## Applicable Urban Design Priorities Project Should Achieve

## Deep Ellum Garage + Office

# **DEEP ELLUM BOMB FACTORY OFFICE**

UDPRP Presentation, February 22, 2019

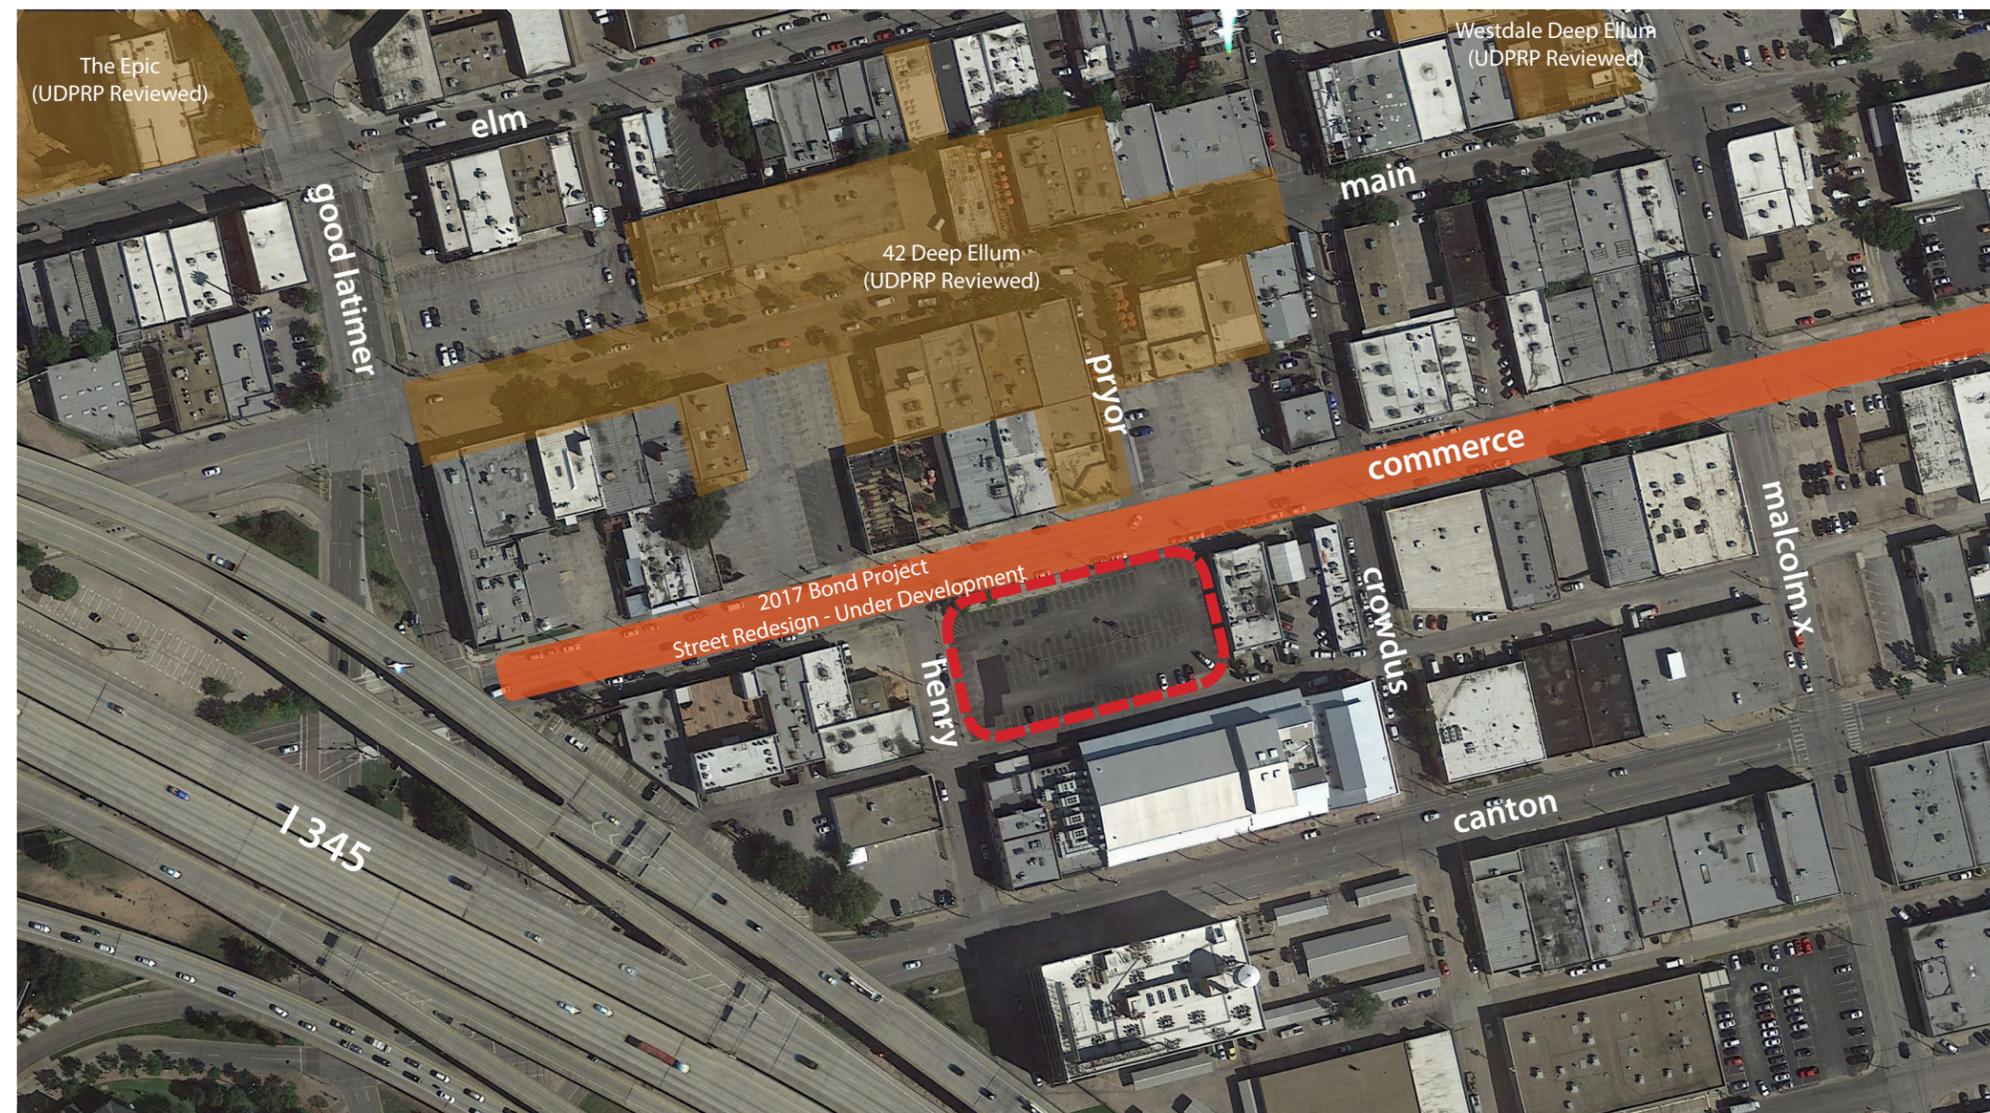
### [2] Explore further parking reductions and underground parking as a means to reduce the overall height and mass of the structure.

The surrounding development along Commerce Street is predominantly one and two story historic buildings. Considering the proposed development's context and its excess parking, there is an opportunity for the development to provide fewer parking spaces in order to reduce the overall required height for the development. Furthermore, the development team should explore remediation opportunities and sources of funding to provide a strategy to relocate some of the parking below-grade.
